Contract No. T201330009.01
Federal Aid Project No. ESTP-N061(01)
Industrial Track Greenway Phase III
New Castle County

Enclosed is Addendum No. 3 for the referenced contract consisting of the following:

INTERIOR POST CONNECTION PLATE - PLAN
SCALE: 3" = 1' - 0"

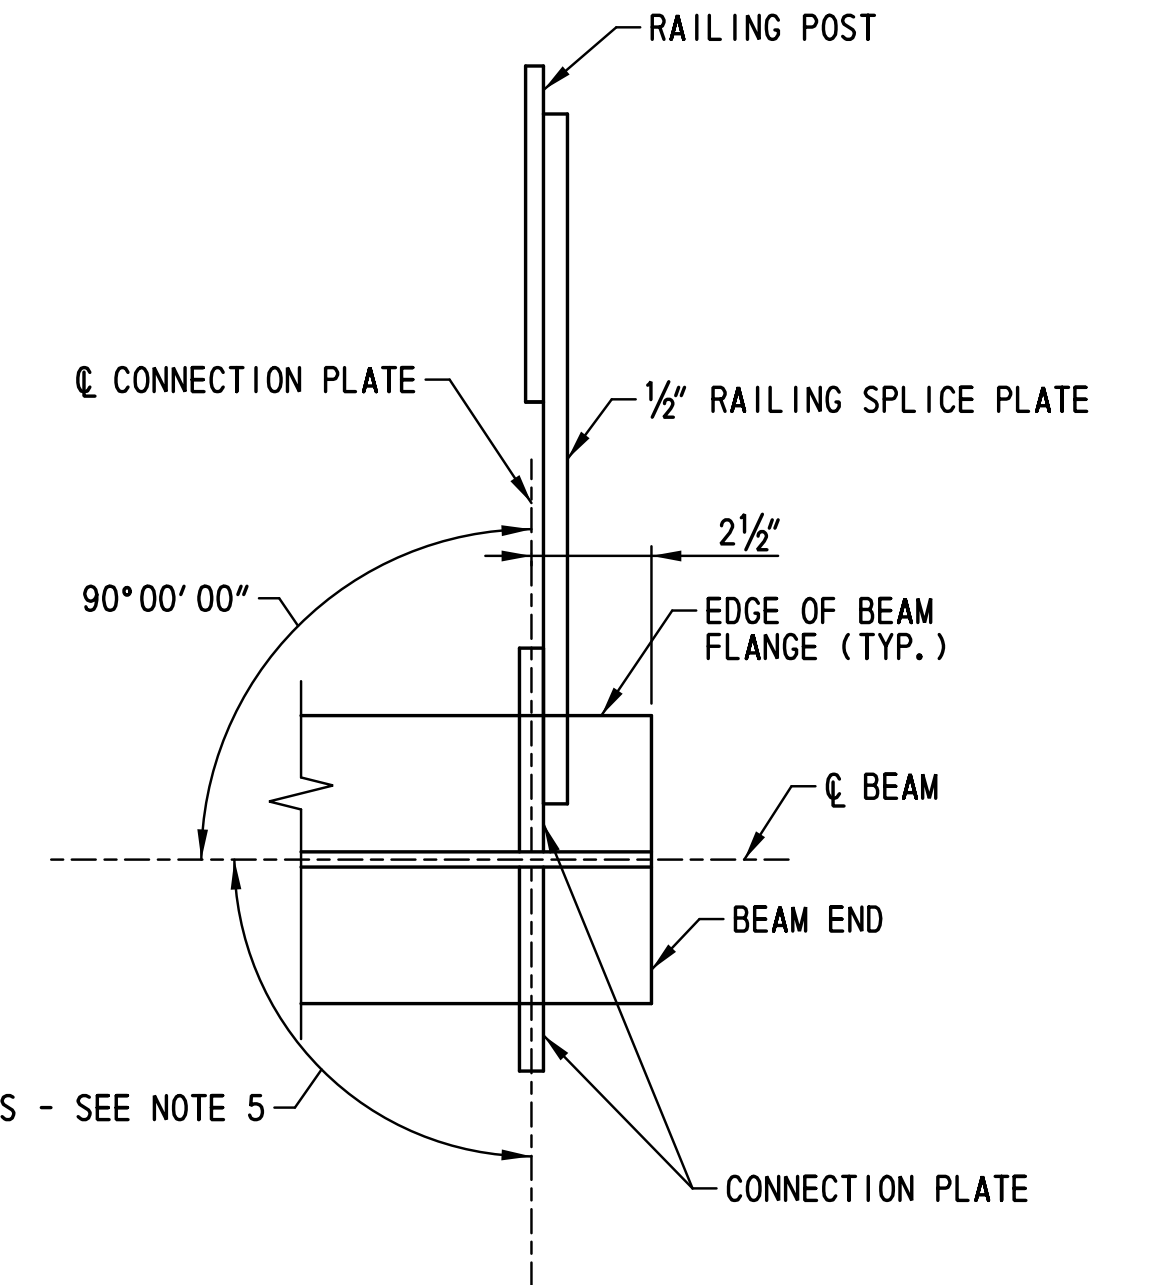
△ GALVANIZED STEEL WIRE MESH PANEL:
NO. 8 GAUGE, 1 1/2" WOVEN WIRE
MESH CINCHED AND CENTERED TO 1" X 1/2" X 1/8"
C-CHANNEL FRAME, PREFABRICATED (TYP.)

ADDENDUMS / REVISIONS	
△	REV. DETAIL NOTE: A.D./J.N. 03/02/16
	REV. SHEET NOTES: A.D./J.N. 03/02/16

- ALL BOLTS SHALL BE 5/8" DIA. STAINLESS STEEL CONFORMING TO ASTM A193 B8 CLASS 2. ALL HOLES SHALL BE 1/8" DIA. MISCELLANEOUS FASTENERS USED FOR SPACER AND RAILING CONNECTIONS SHALL BE TYPE 304 STAINLESS STEEL.

- RAILING POST AND PLATE MATERIALS SHALL BE ASTM A36 STEEL OR APPROVED EQUAL AND GALVANIZED IN ACCORDANCE WITH ASTM 123. ALL STAINLESS STEEL TUBE SHALL BE TYPE 304 STAINLESS STEEL, CONFORMING TO ASTM A269 OR APPROVED EQUAL. WOVEN WIRE MESH INFILL PANELS SHALL CONSIST OF NO. 8 GAUGE WIRE MATERIAL MEETING THE REQUIREMENTS OF ASTM A 853 AND GALVANIZED IN ACCORDANCE WITH A 123.
